**Edwin I. Hatch Nuclear Plant - Unit 2**

**Re-review of Subject Information Provided with Respect to 10CFR 2.390 As  
Requested in NRC Draft SER Letter of February 12, 2009**

**GE-NE-000-0080-0259-NP-R4; Hatch 2 Nuclear Plant Shroud Repair  
Replacement of Upper Support Stress Analysis Report**

Edwin I. Hatch Nuclear Plant – Unit 2  
Response to NRC Request for Additional Information Regarding  
Modification of the Core Shroud Stabilizer Assemblies (TAC No. MD9579)

Figure 1 - Tie Rod/Spring Assembly Parts

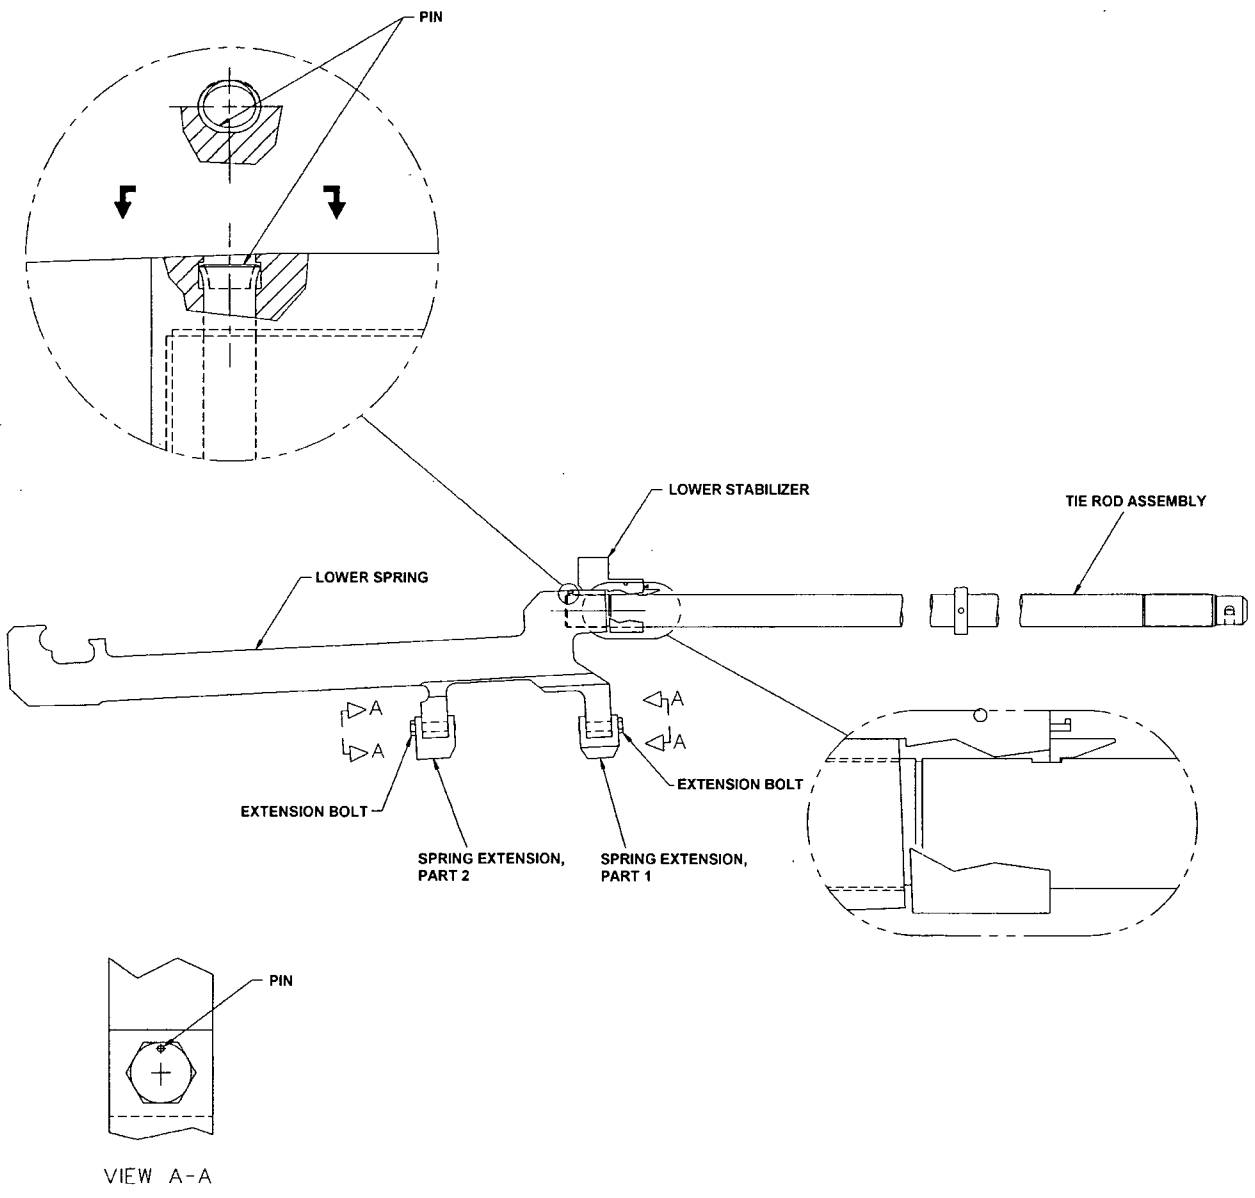
Section 2, "Background," in Enclosure 1 to the September 3, 2008, letter indicates that the cause of the cracking in the upper supports in the shroud stabilizer assembly was intergranular stress corrosion cracking (IGSCC) of the Alloy X-750 material. Alloy X-750 material is susceptible to IGSCC if subjected to sustained, large peak stress conditions. The Boiling Water Reactor Vessel and Internals Project (BWRVIP) issued letters dated March 29, 2006, and April 3, 2006, requiring plants with core shroud tie rod repairs to inspect their repairs at their next scheduled refueling outage. These letters indicate inspections should include all the same or similar locations where indications were observed at Hatch, Unit 1 (Hatch-1) during the unit's 2006 refueling outage and that consideration should also be given to other locations in the tie rod repair where X-750 material is used and which may experience high-sustained stresses.

<b>Tie Rod/Spring Assembly (Figure 1)</b>
Spring, Lower
Contact, Lower
Latch
Spring Extension, Part 1
Spring Extension, Part 2
Bolt, Extension
<b>Collet Assembly (Figure 2)</b>
Collet
Clevis Pin
Cruciform Spacer
Bolt
Torque Restraint, Part 1
Torque Restraint, Part 2
Cruciform Spacer, Part 2
Cruciform Rod
Latch
Torque Restraint, Part 3
Bolt, Torque Restraint

Hatch 2 Replacement Upper Support Assembly	Hatch 2 Replacement Support

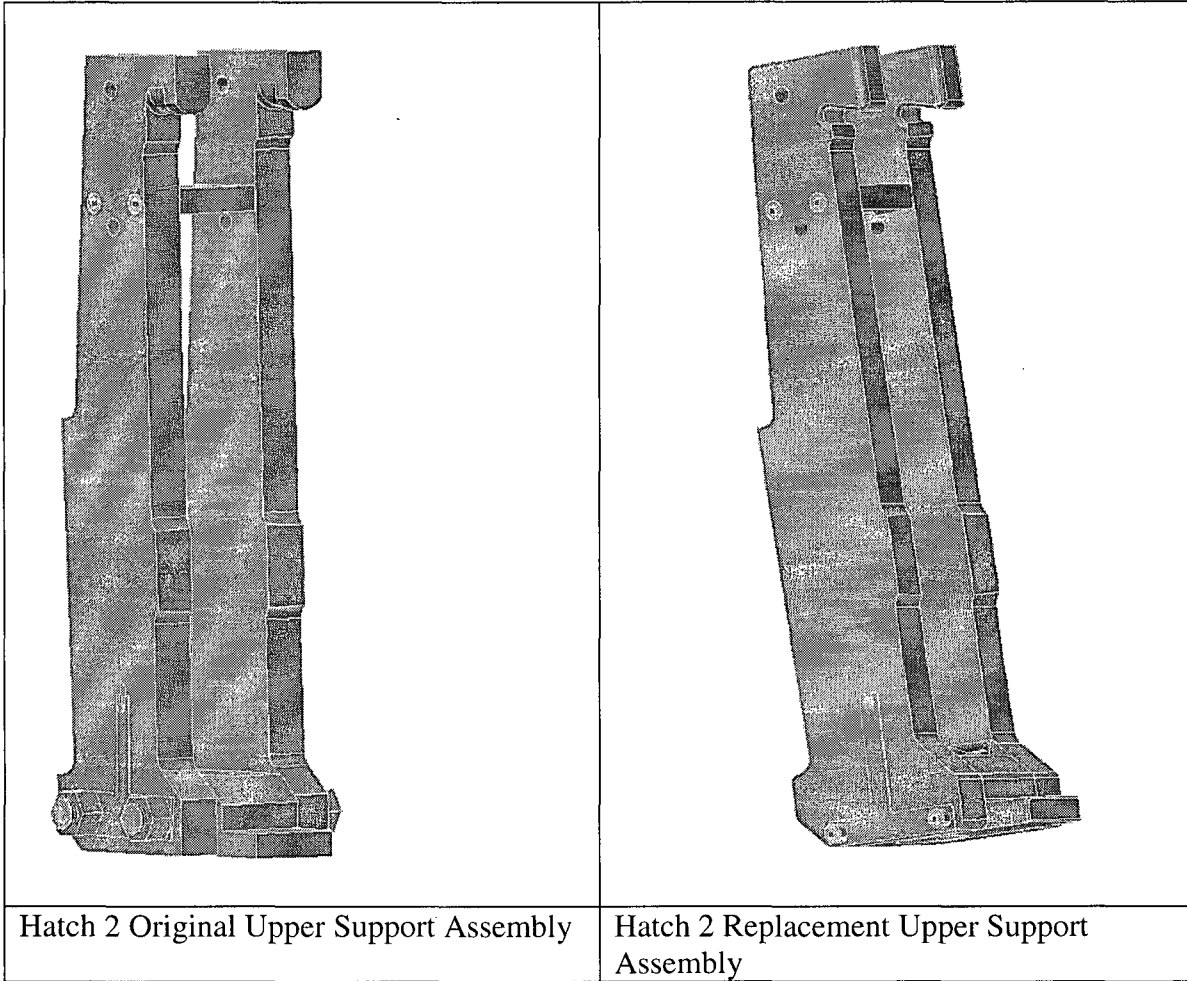
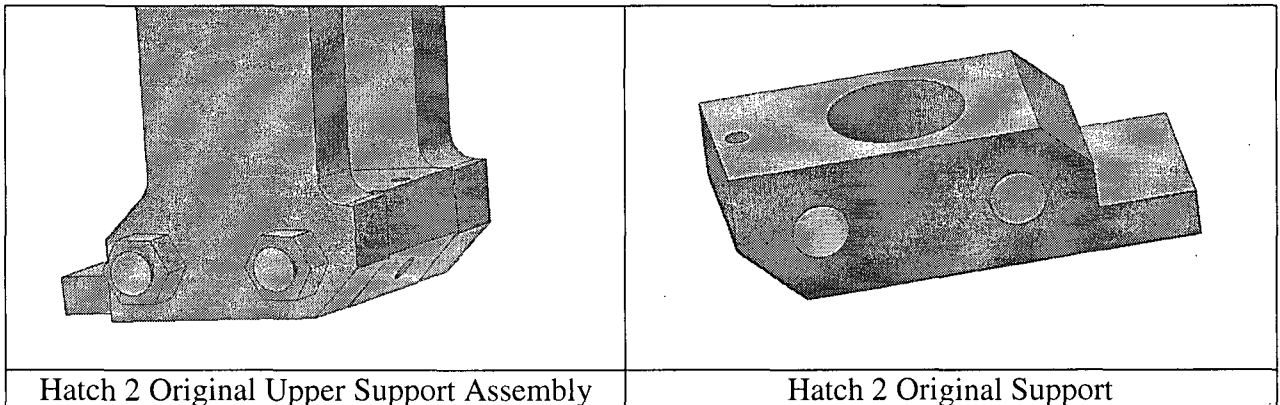
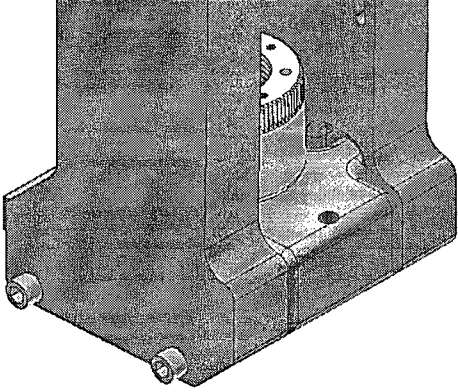
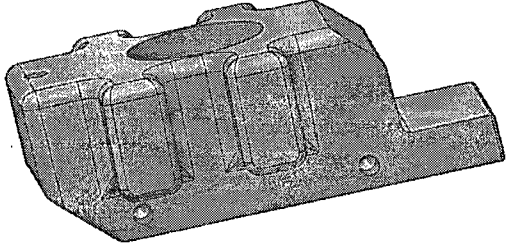
*Section 3 of Enclosure 3 and Section 3.3 of Enclosure 1, show the replacement upper support components and contain a brief description of the components that will be repaired/replaced. Provide a drawing (or pictorial) that illustrates the differences between the original and the proposed replacement upper components for comparison. Also identify dimensionally, the proposed changes to the shroud head flange.*

The upper supports will be replaced in their entirety. The primary difference between the original and the replacement is the shape of the contact surface that interfaces with the shroud flange pocket. The original upper support has a circular surface, while the replacement upper support has a flat surface as well as a larger fillet radius at the horizontal to vertical transition.

The other difference between the original and the replacement is the support to upper support connection. The replacement support has integral tabs or arms that engage pocket in the upper support, which provides a direct load path between the support and upper support (instead of the Alloy X750 thru bolts used in the original upper support assembly). This allows the support to be made from Type XM-19 material instead of Alloy X750. See Figure 6-2.

There are no proposed changes to the shroud head flange. The changes to the shroud flange are discussed in the response to EMCB RAI 3 a)

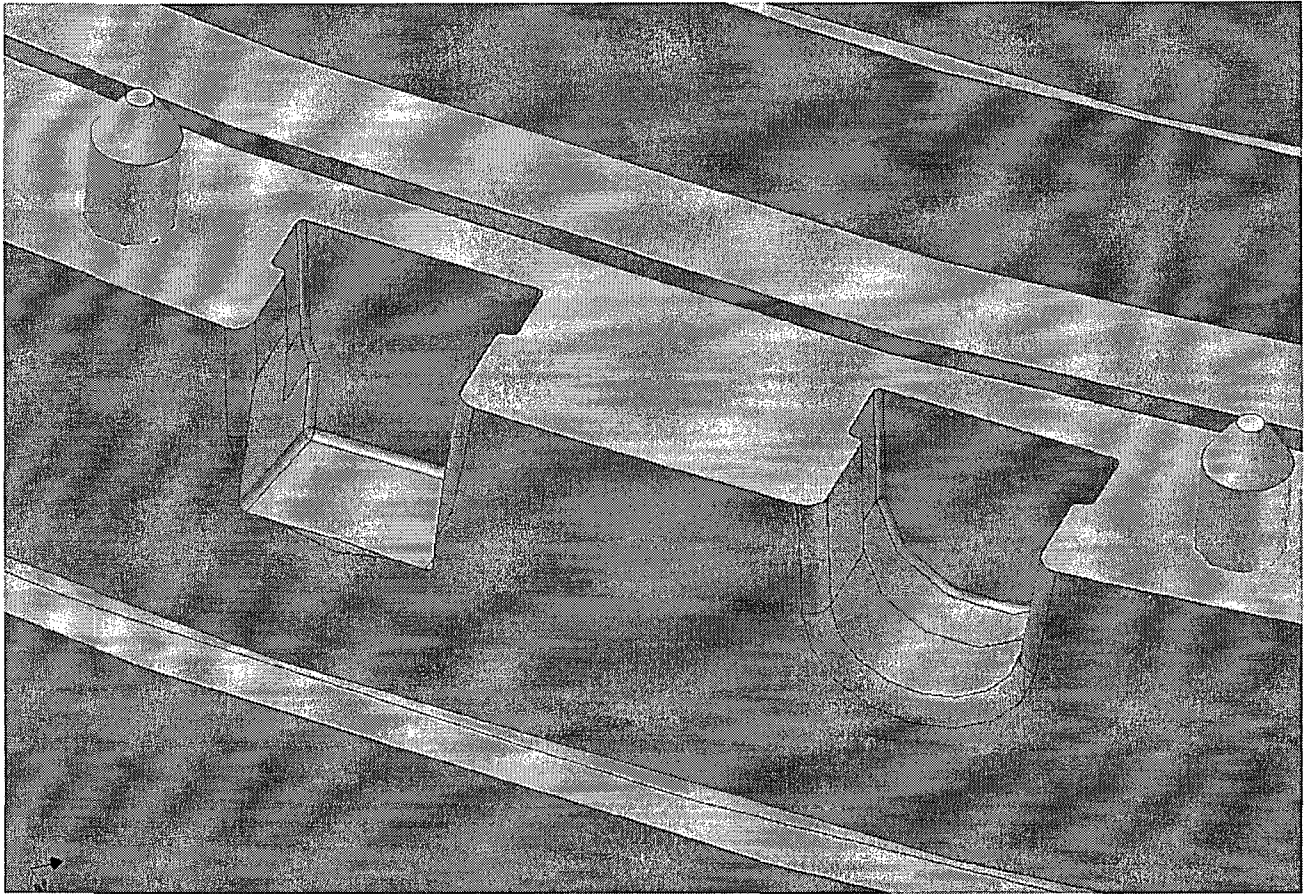
*a) Describe in detail the proposed changes to the core shroud.*

The figure above shows a comparison of the existing versus the proposed changes to the shroud flange slots. The slot on the right is the existing slot. The slot on the left is the modified slot. The proposed change flattens the bottom of the slot over a width of 2.90" at an angle of 15 degrees to horizontal.  
SNC Scope.
